Subject Revised Work Plan for Historical Water Supply Well Reconnaissance, Topock Compressor Station, Needles, California

Date April 25th, 2019

Attachment 1
Tabulated Response to Comments

Attachment 2
Drawing Number 580885

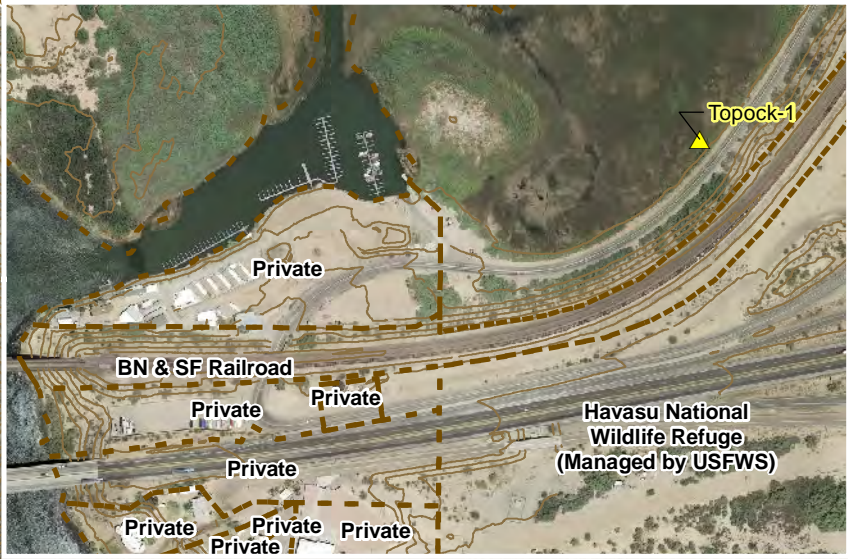
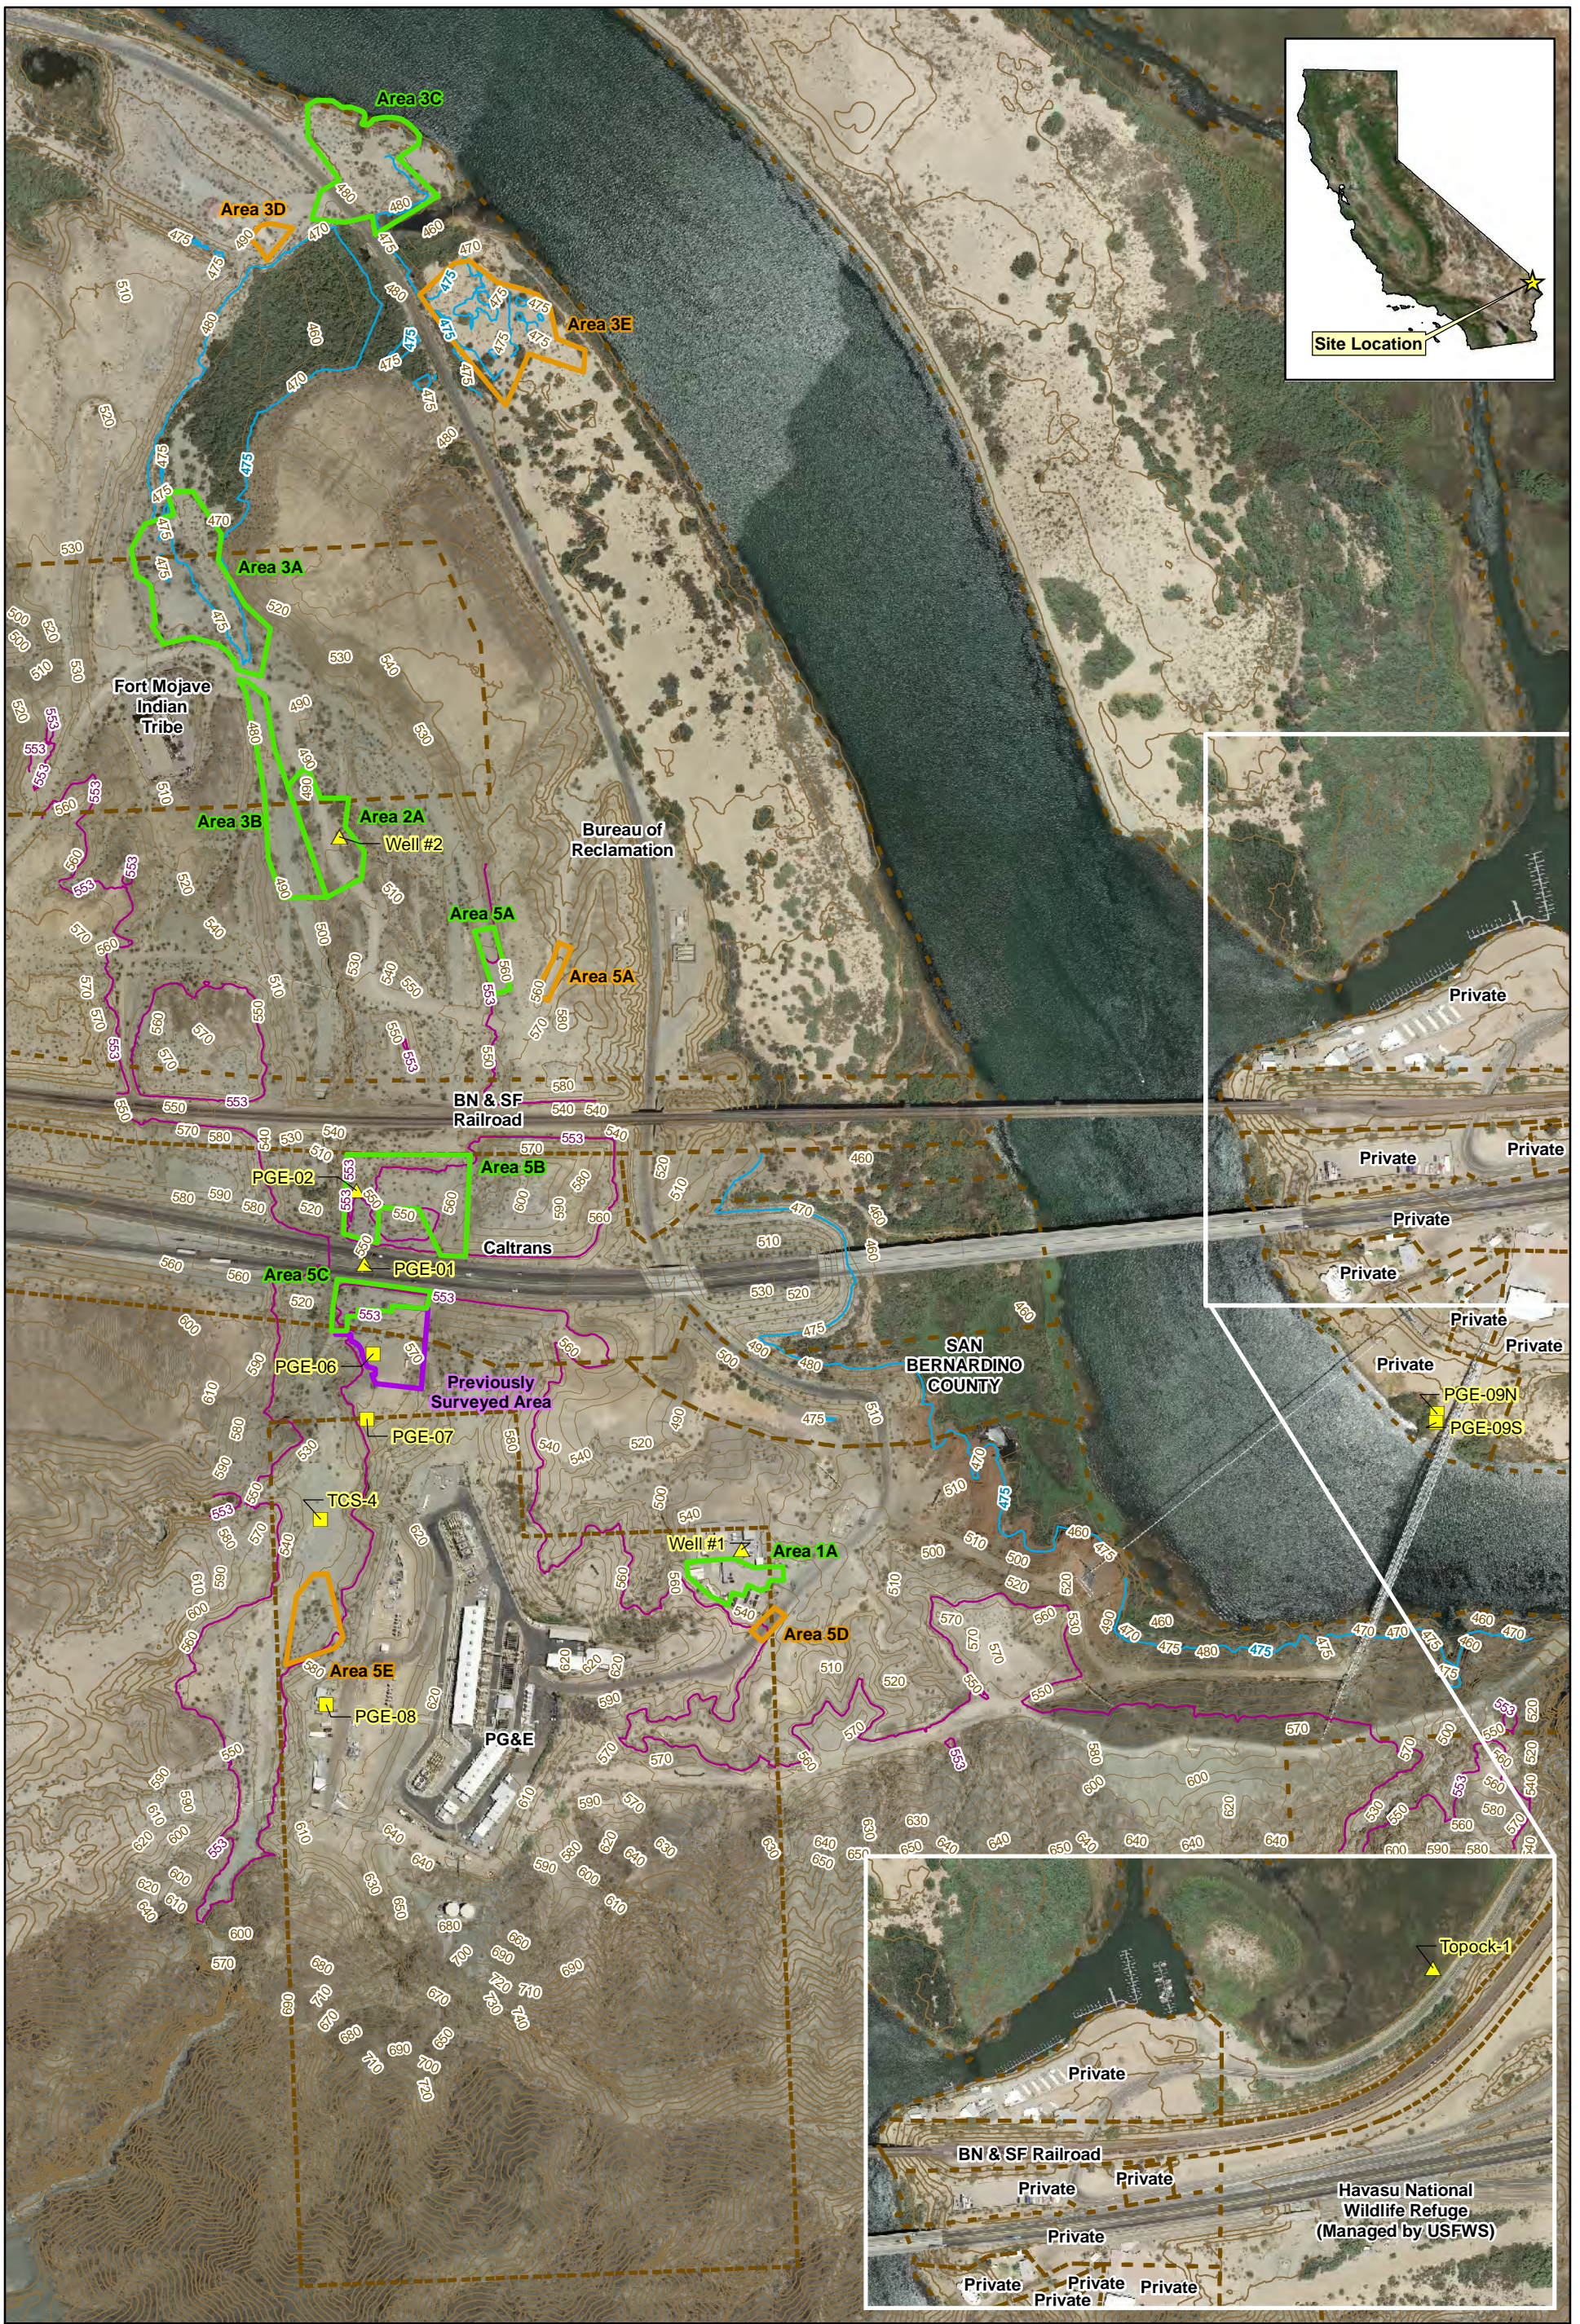
E	<p><u>Page 4, Section 6 Proposed Survey Areas, Well #1 - Area 1A</u>: Figure 2 shows Well #1 located within both the Transwestern facility as well as on PG&E property south of the Transwestern facility. Using image overlays, the GSU independently found Well #1 to be located at the northeast</p>	Drawing 580885 included as an attachment.

FIGURE 1
Water Supply and Historical Well Locations
 Historical Water Supply Well Reconnaissance
 Pacific Gas and Electric Company Topock Compressor Station, Needles, California

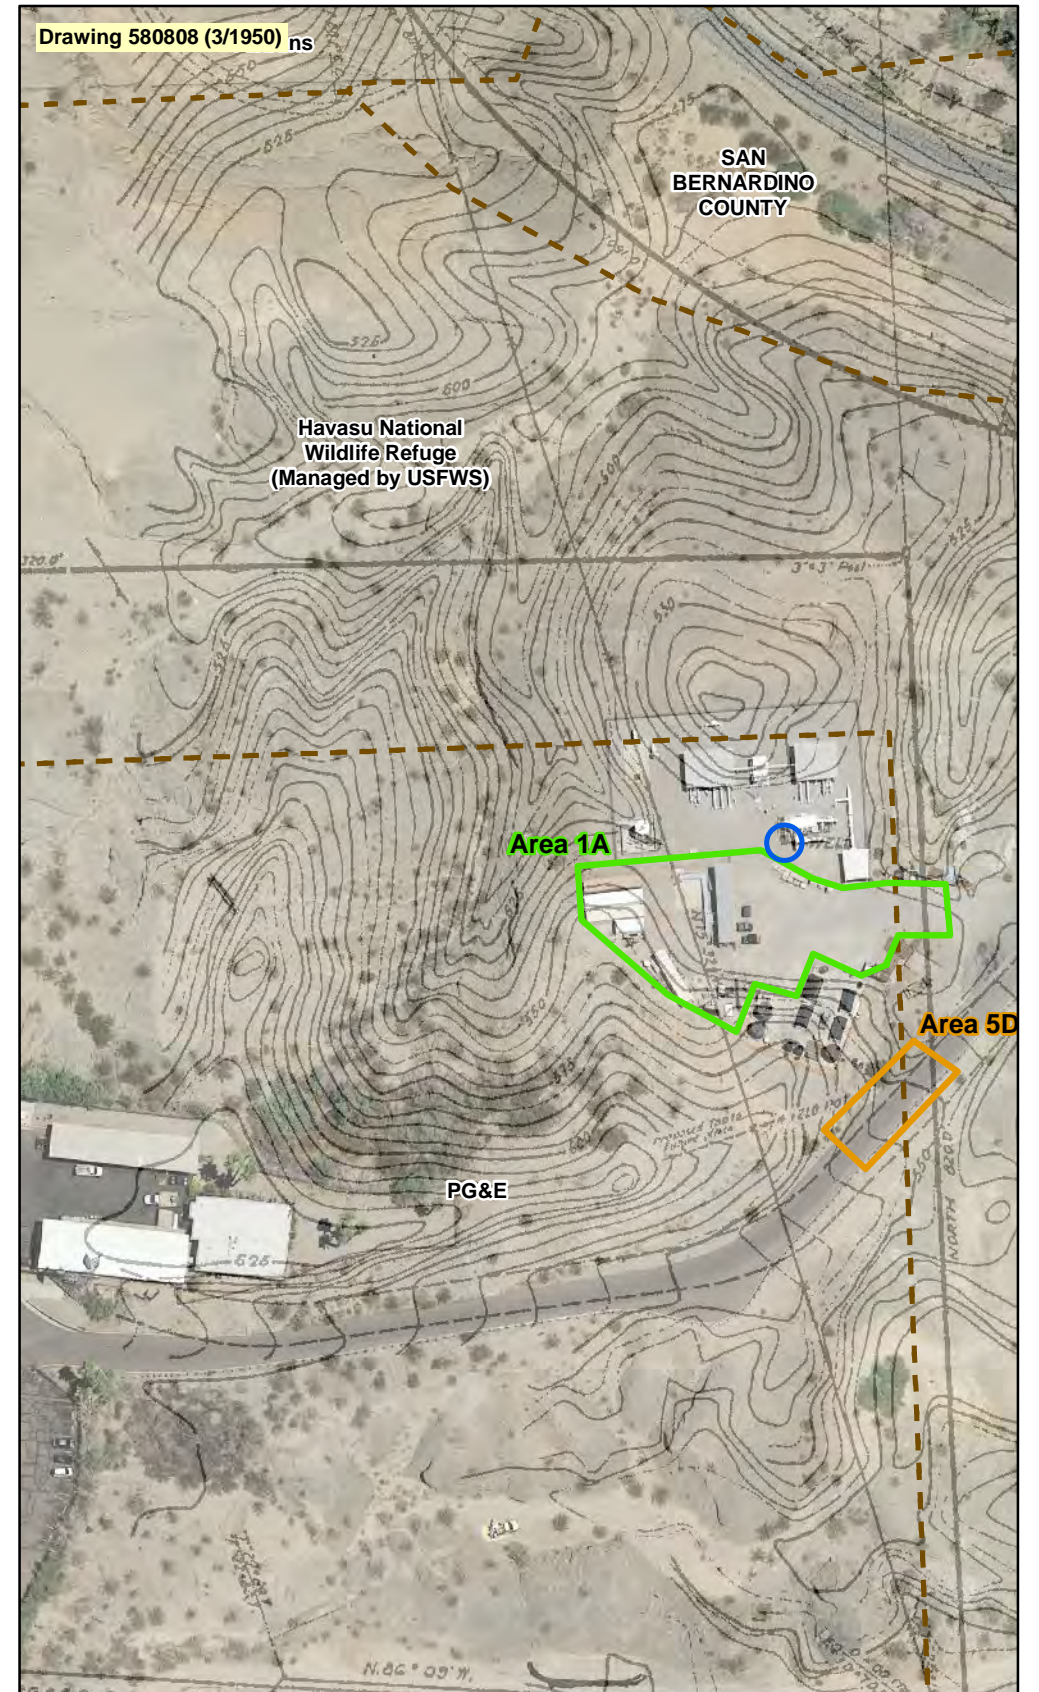
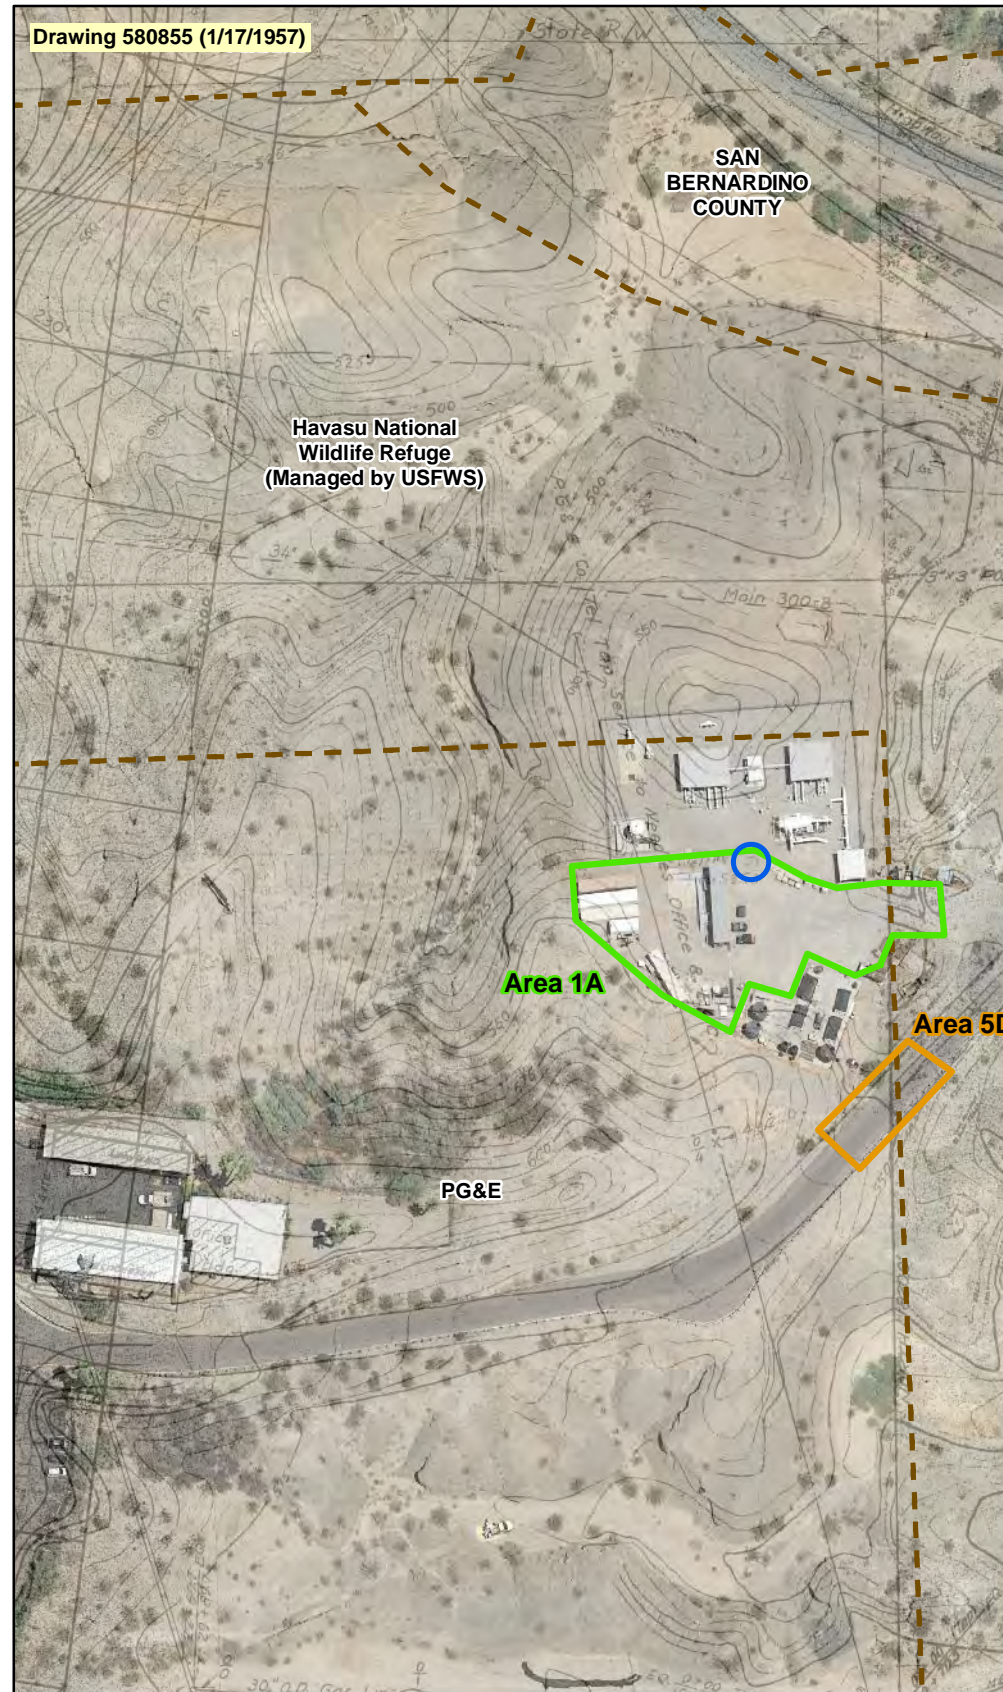
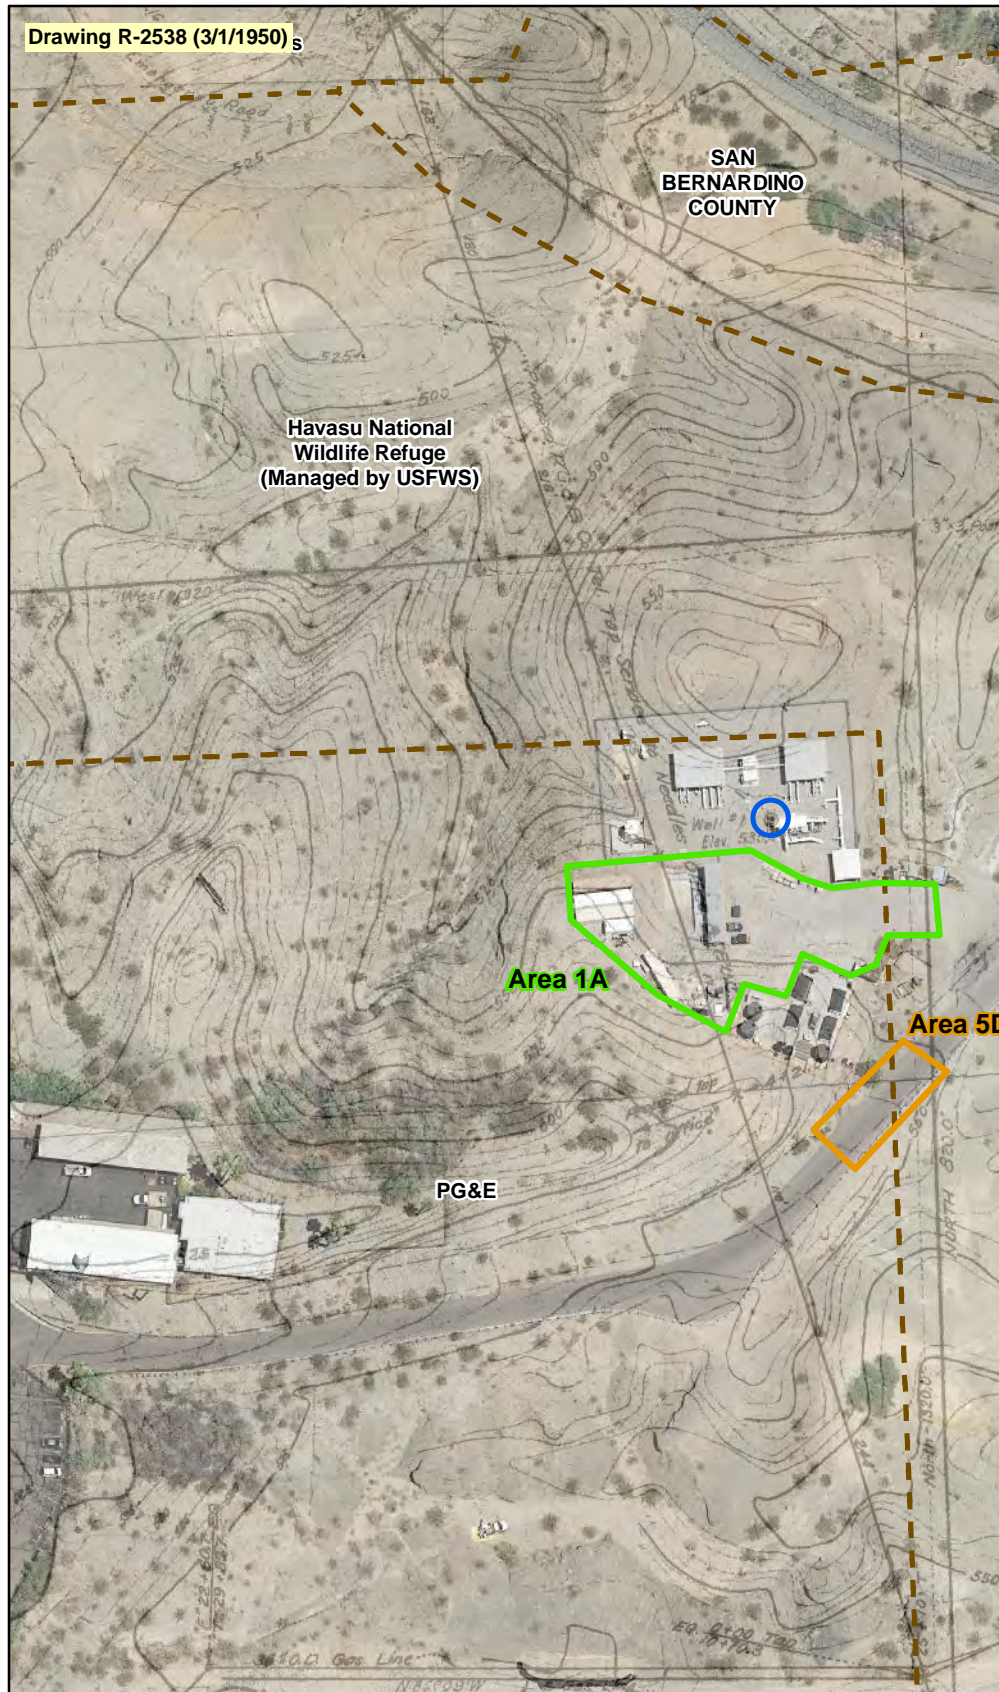
<p>G</p>	<p><u>Page 5. Section 6 Proposed Survey Areas, Well #3 - Area 3D:</u> This section eliminates the existing well near the former resort from further consideration largely due to its smaller well diameter. For completeness, the Recon Work Plan should be revised to specify the diameter of the existing well in this area and the known and anticipated diameters of all the 1950 era wells. Should it turn out that smaller diameter historic wells be discovered in the future at other survey areas, this existing well may need to be reevaluated.</p>	<p><u>Section 5. Proposed Survey Areas, Area 3D (Eliminated)</u></p> <p>Text and citation added:</p> <p>This area is west of Area 3C and was identified based on a DTSC comment that a well casing of unknown origin is in the vicinity (west of the existing concrete pad). Like Area 3C, the area is flat and physically disturbed, but is considered less likely based on the distance from TCS. This area has been eliminated because there is no documentation suggesting that this well was installed by PG&E and the casing diameter is smaller than that of known historical TCS water supply wells from same era (e.g., TCS-4). Historical water supply well TCS-4 (now decommissioned) was a ten-inch diameter mild steel casing with a twelve-inch conductor casing. Other historical supply wells of this era are expected to be similar diameter¹². During field activities, the smaller diameter well in this area will be measured and documented.</p> <p>Citation added to footnotes:</p> <p>¹² PG&E's July 2014 Letter reference 37, <i>Draft Design Criteria and Specification Summary Industrial Water Well Supply Well Installation</i></p>

This area is west of Area 3C and was identified based on a DTSC comment that a well casing of unknown origin is in the vicinity (west of the existing concrete pad). Like Area 3C, the area is flat and physically disturbed, but is considered less likely based on the distance from TCS. This area has been eliminated because there is no documentation suggesting that this well was installed by PG&E and the casing diameter is smaller than that of known historical TCS water supply wells from same era (e.g., TCS-4). Historical water supply well TCS-4 (now decommissioned) was a ten-inch diameter mild steel casing with a twelve-inch conductor casing. Other historical supply wells of this era are expected to be similar diameter.¹¹ During field activities, the smaller diameter well in this area will be measured and documented.
